Comments in magenta red provided by
Slantern@auroragov.org (Drainage)

PRELIMINARY DRAINAGE REPORT

QUIKTRIP NO. 4245 SITE PLAN WITH CONDITIONAL USE (DA-2350-00)

LOWRY CREDIT UNION FILING NO.1

SHEET TITLE:
POST-DEVELOPED
DRAINAGE MAP

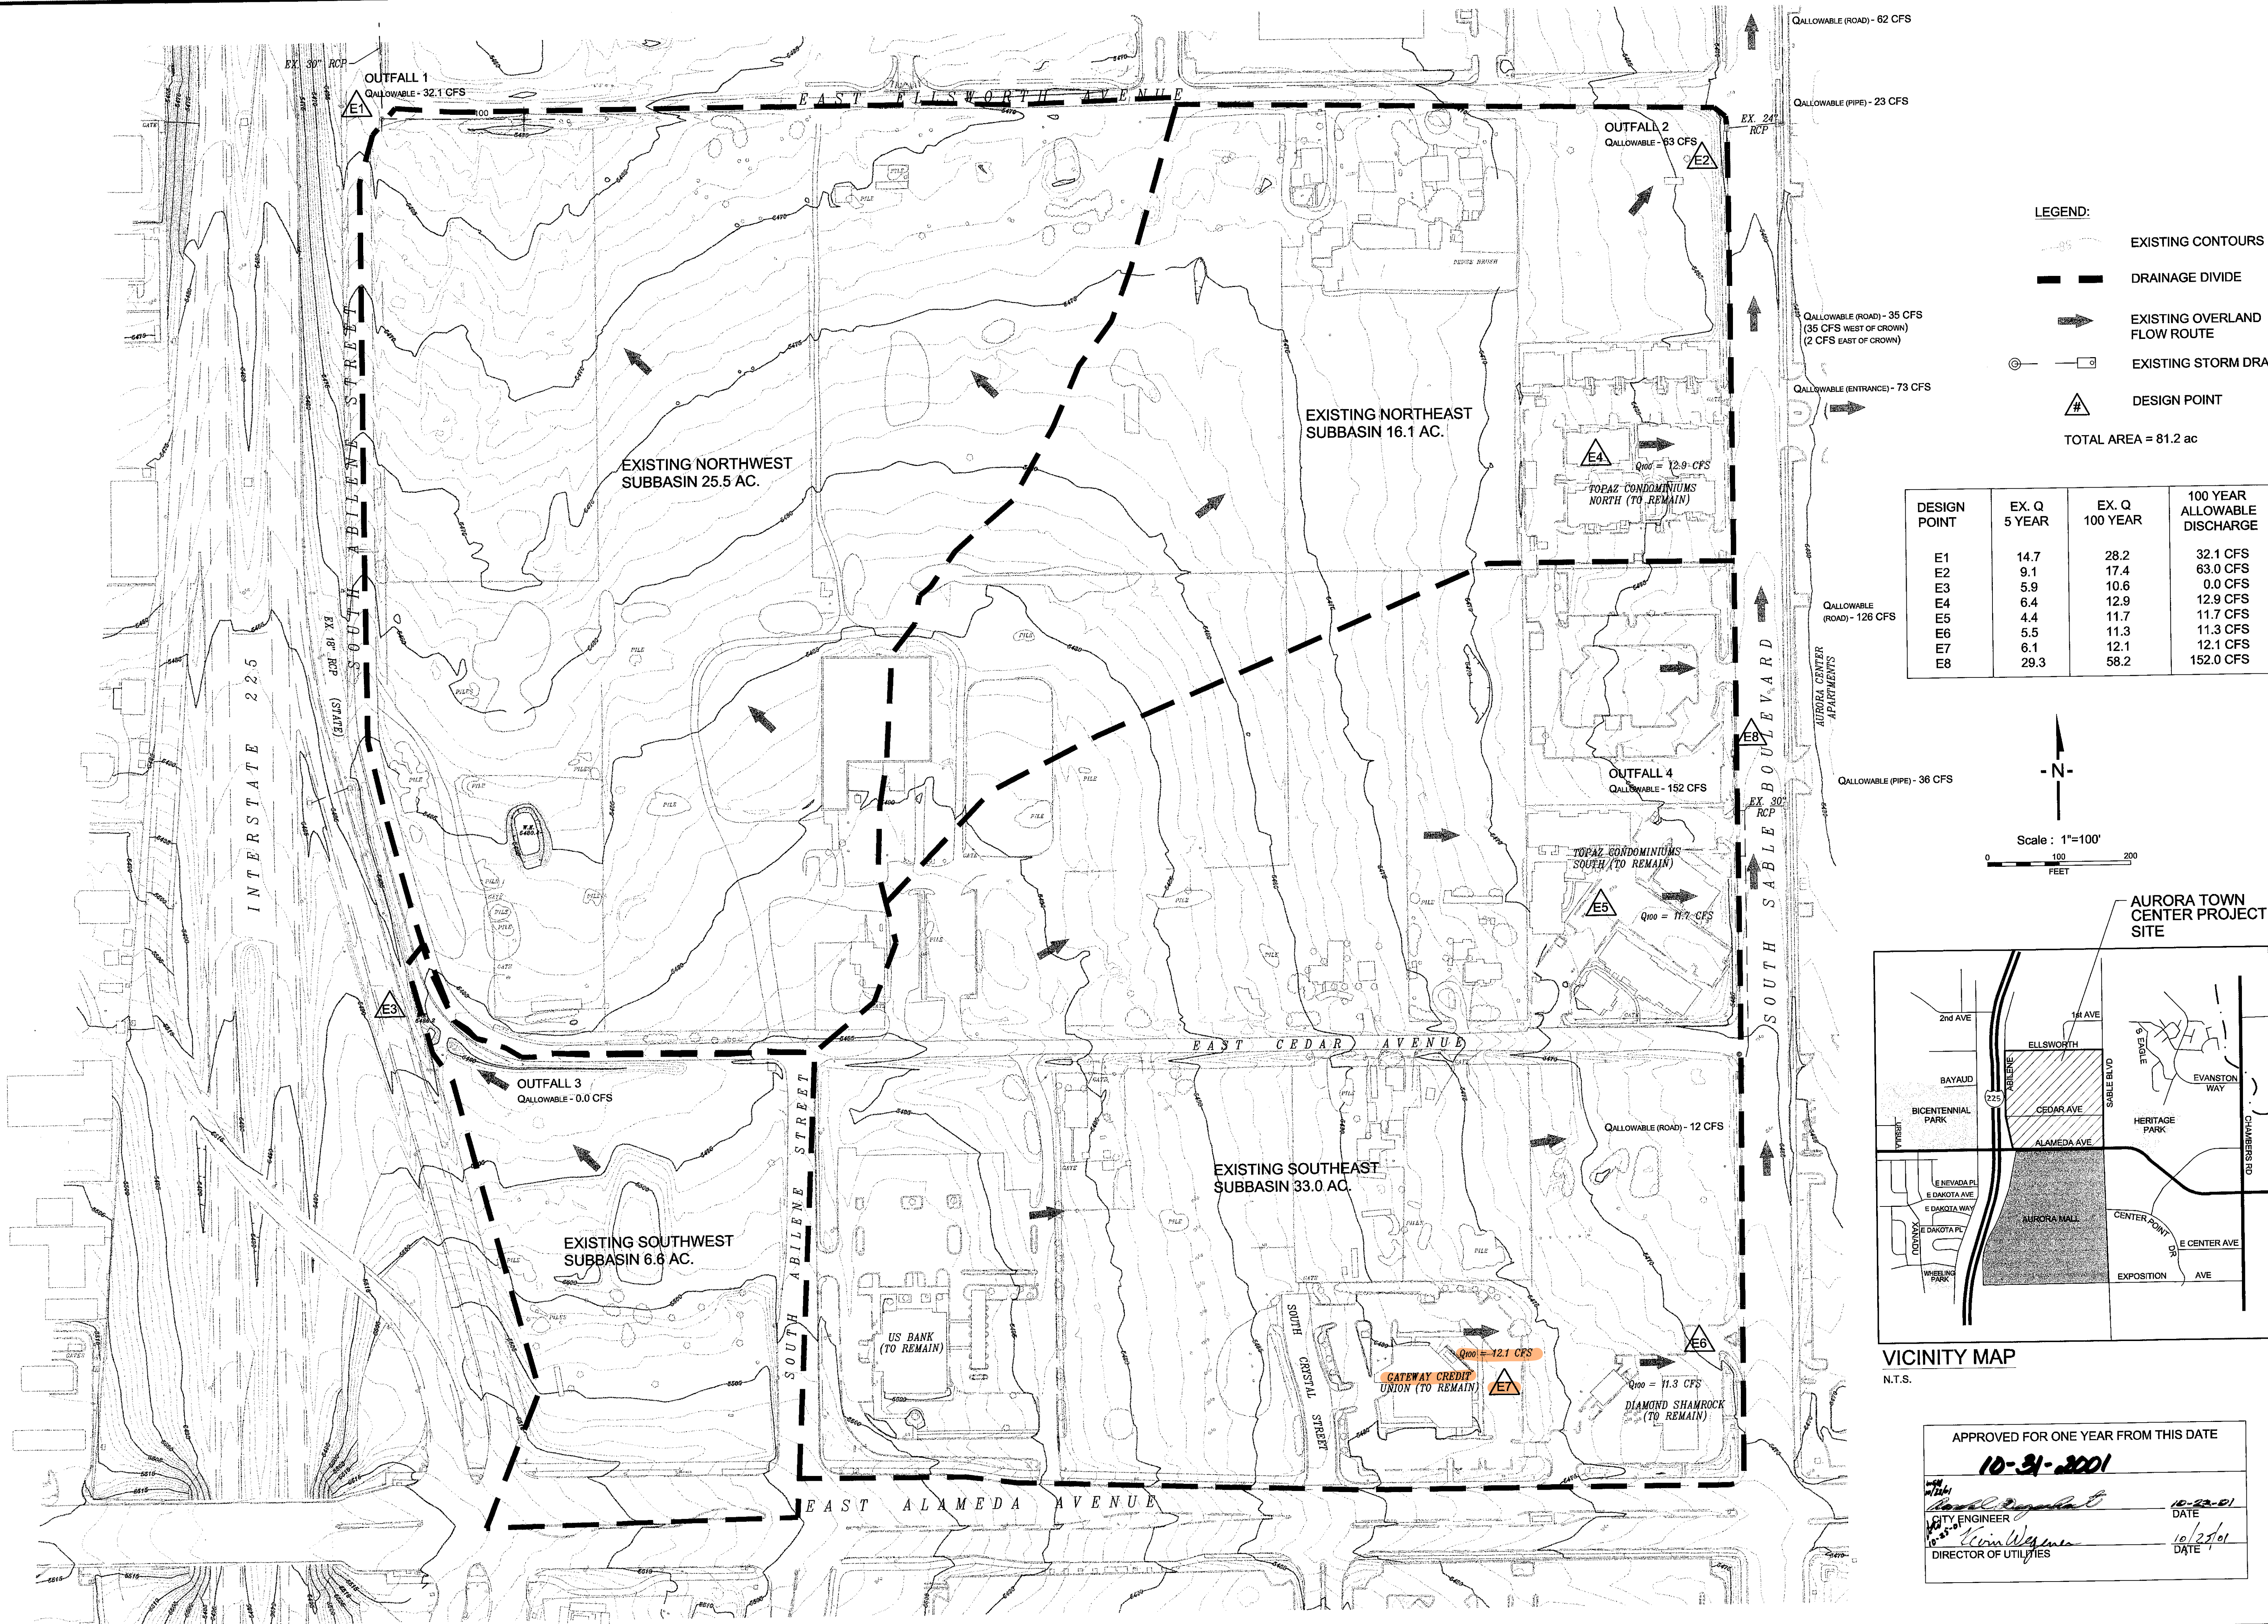
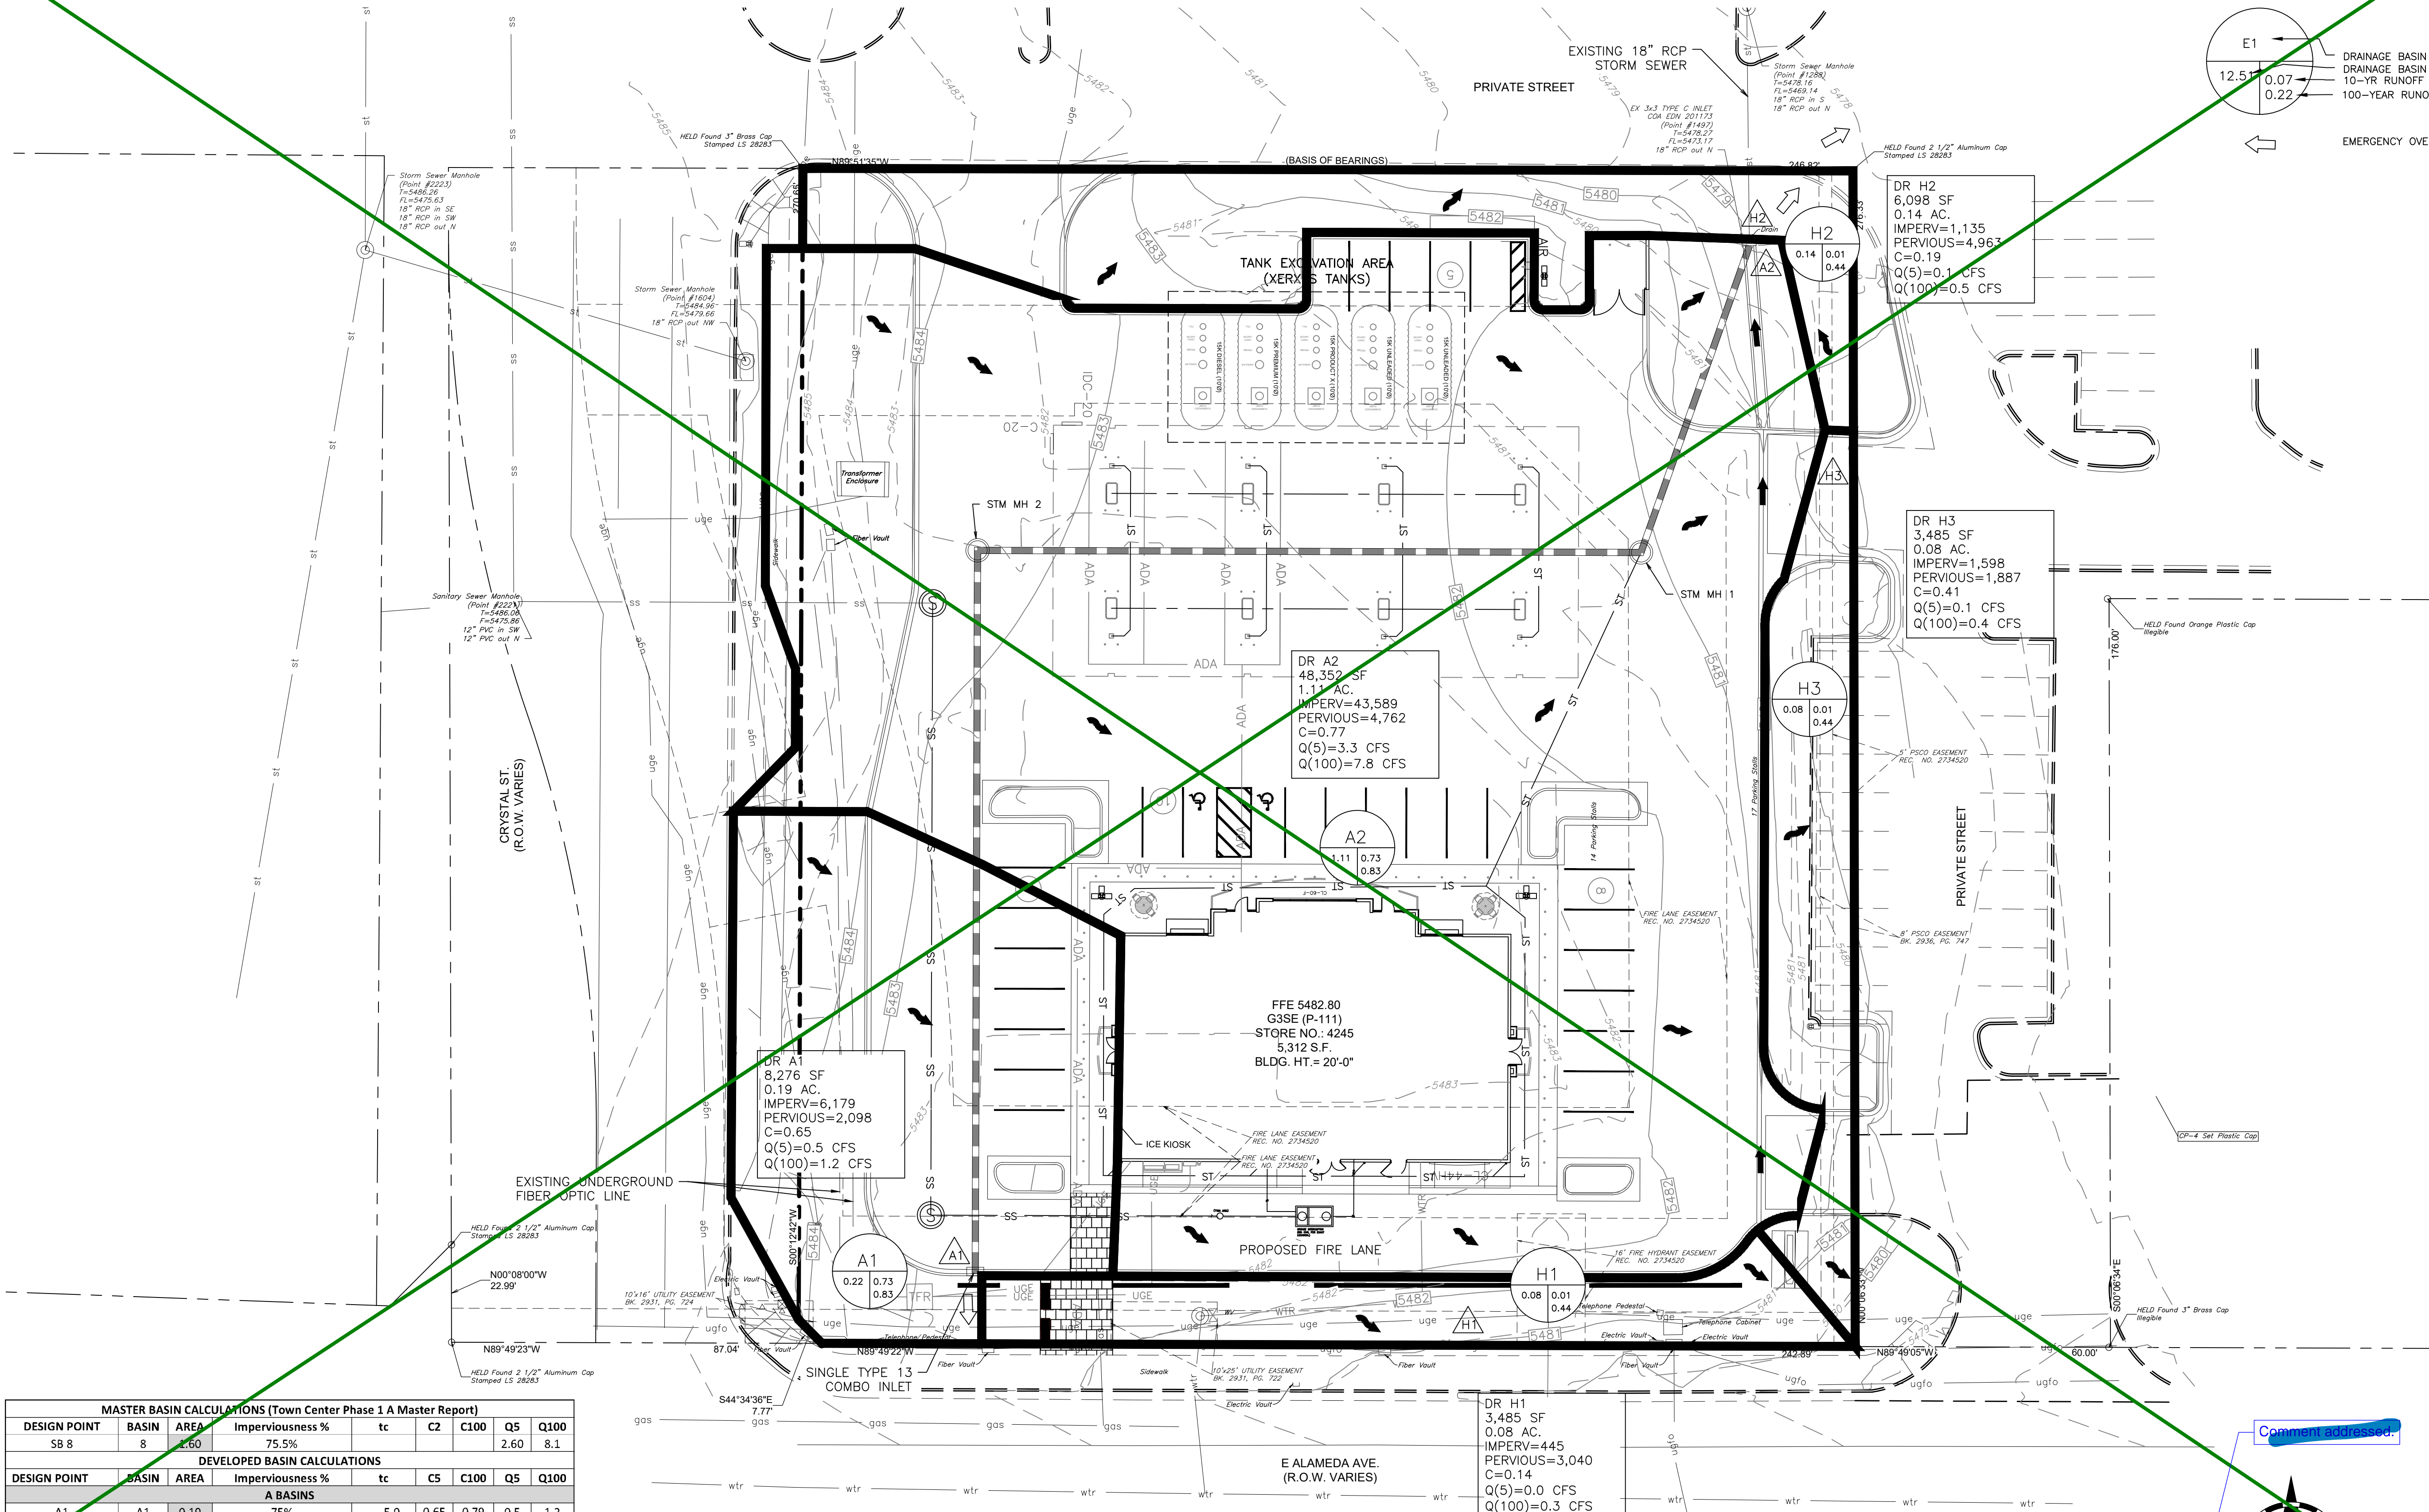
All copyright must be removed from plans so that the city will have no restrictions on reproduction

Plan Sheets included within reports are to be formatted to 8.5x11 or 11x17 size

Comment addressed.

Comment addressed.

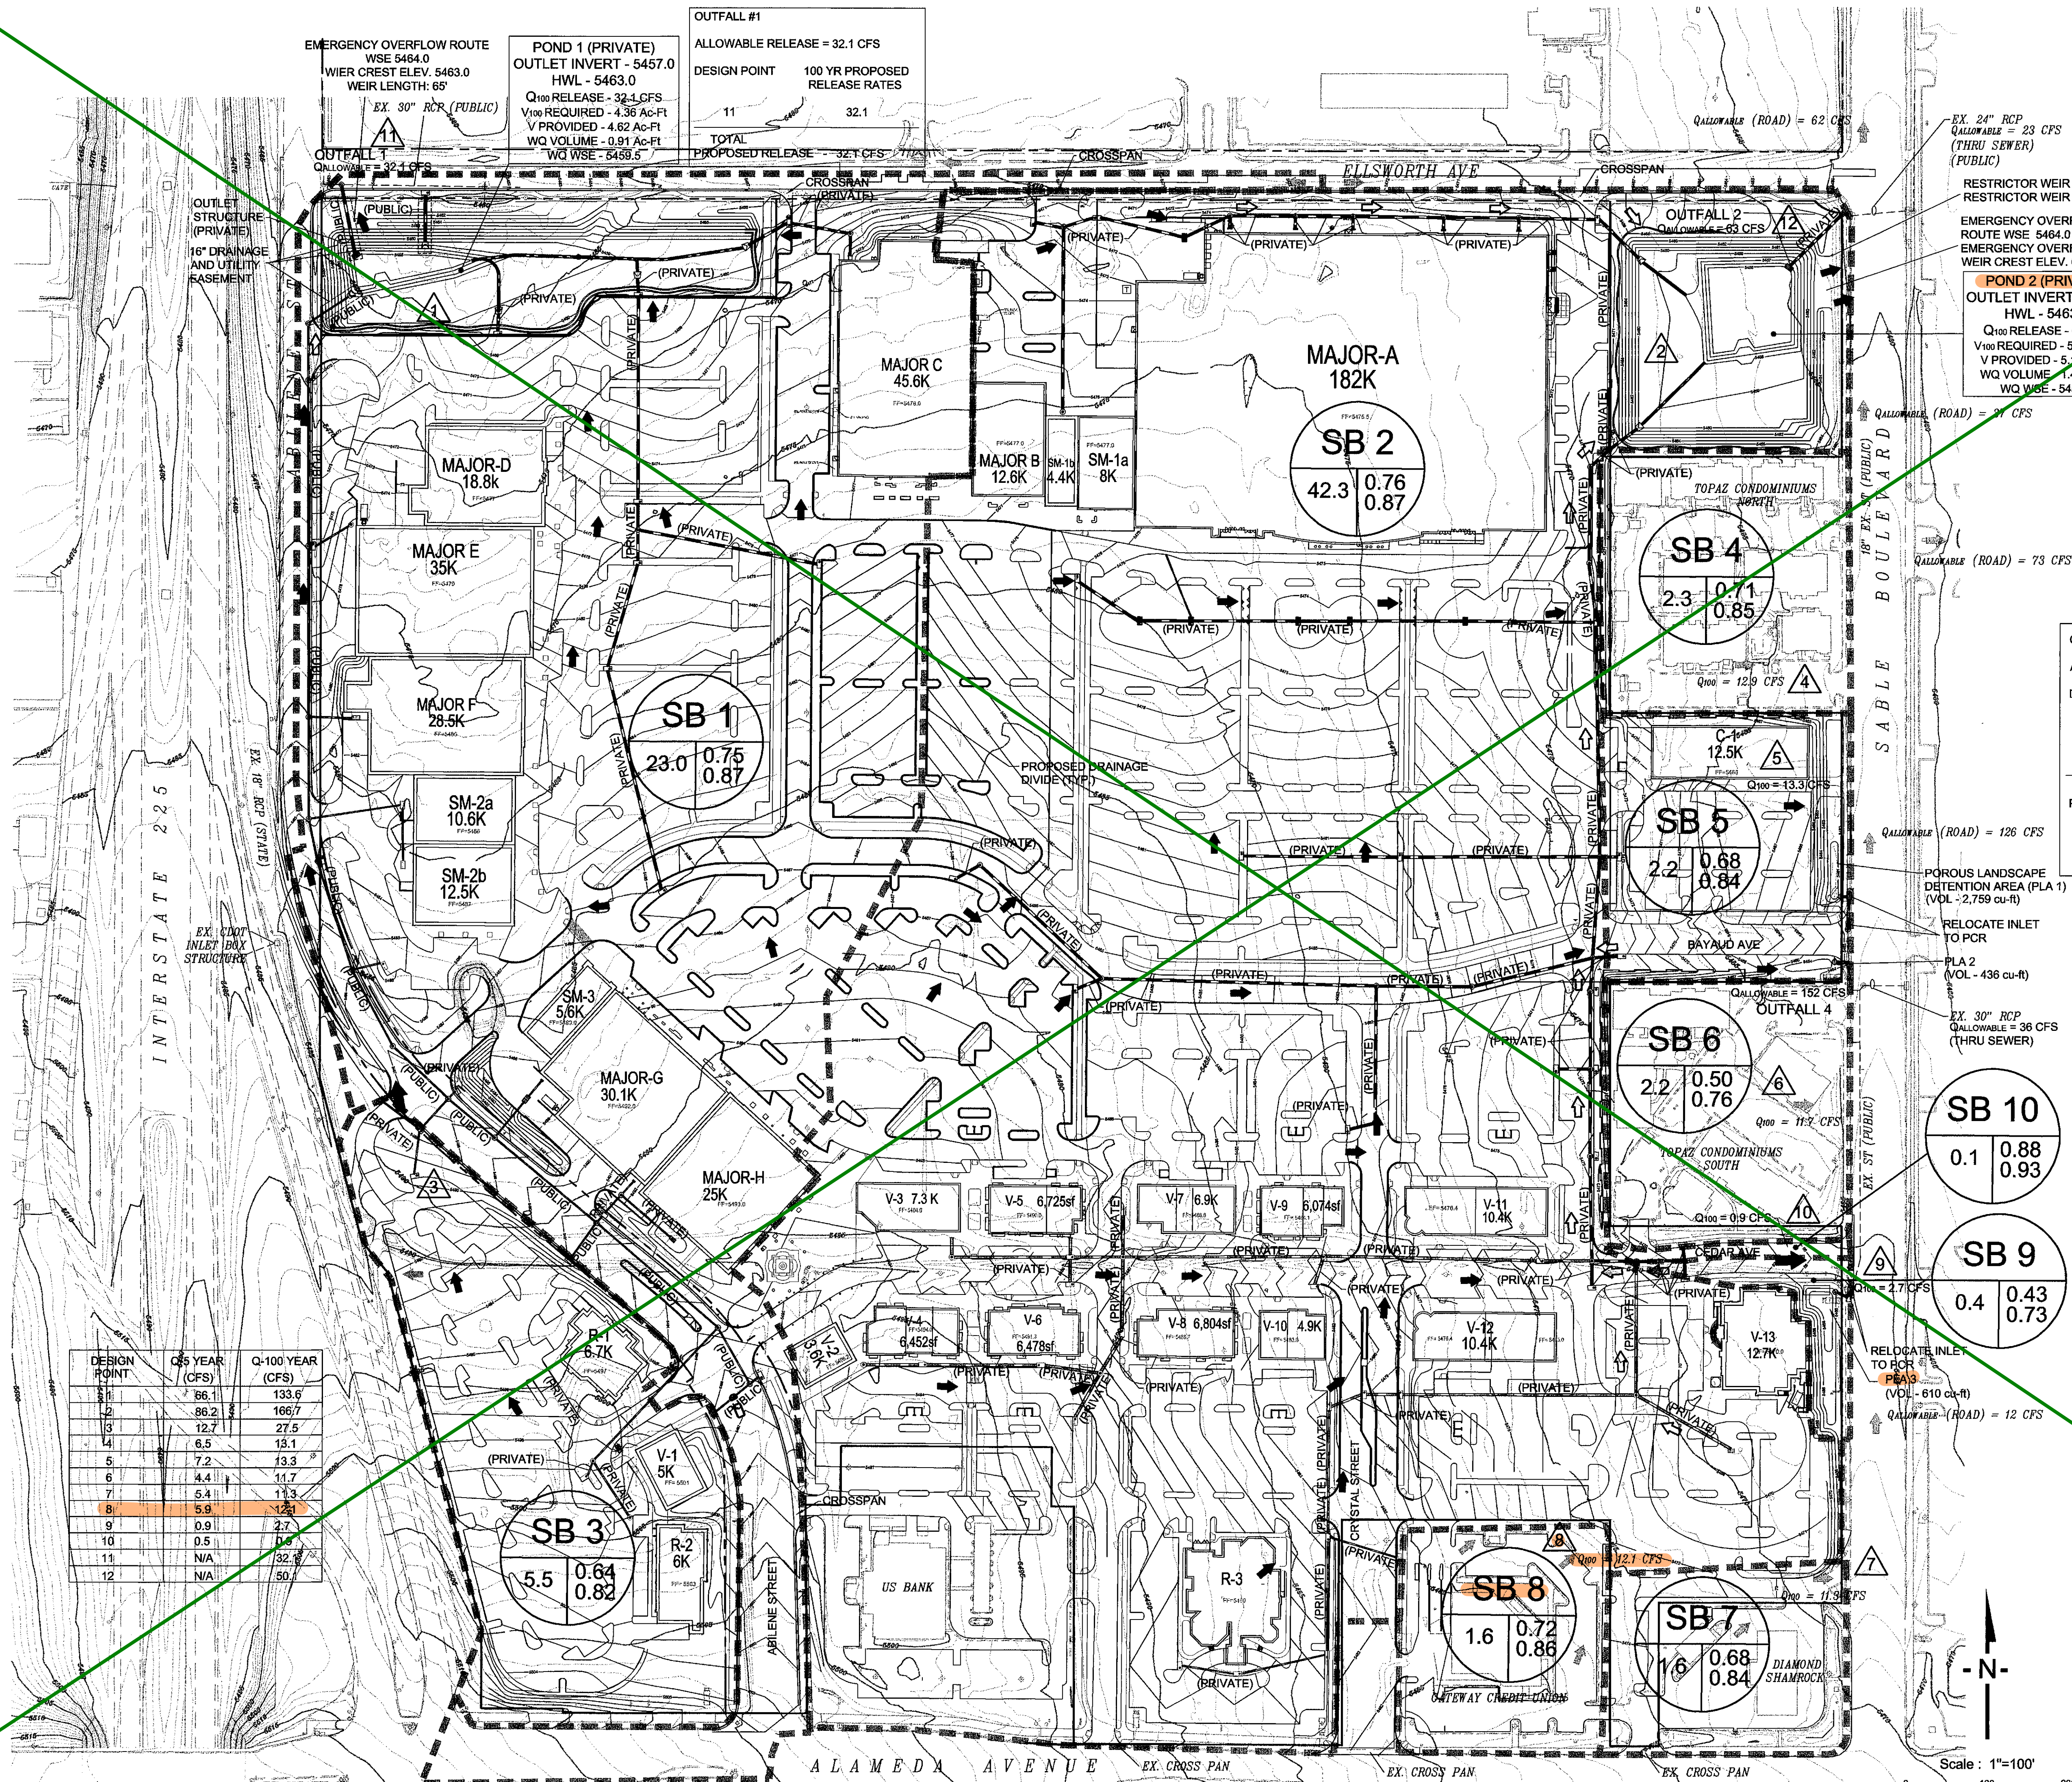
Plan Sheets included within reports are to be formatted to 8.5x11 or 11x17 size

Remove redundant pages

INLET IN A SUMP OR SAG LOCATION

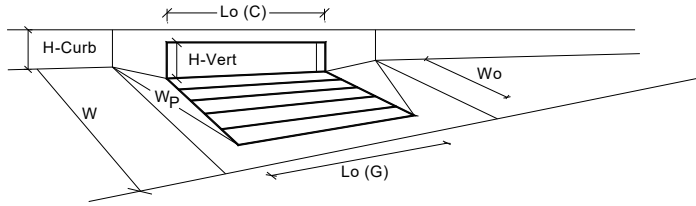
Add Note in large font: "For reference only.
See the Civil Plans for Design Information."

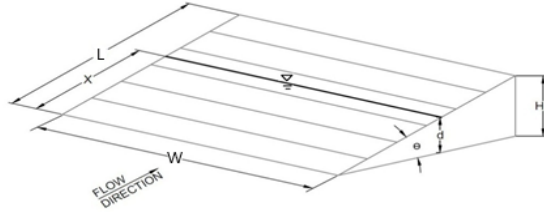
Add Note in large font: "For reference only.
See the Civil Plans for Design Information."

Comment
acknowledged. This
particular calculation
has been removed.
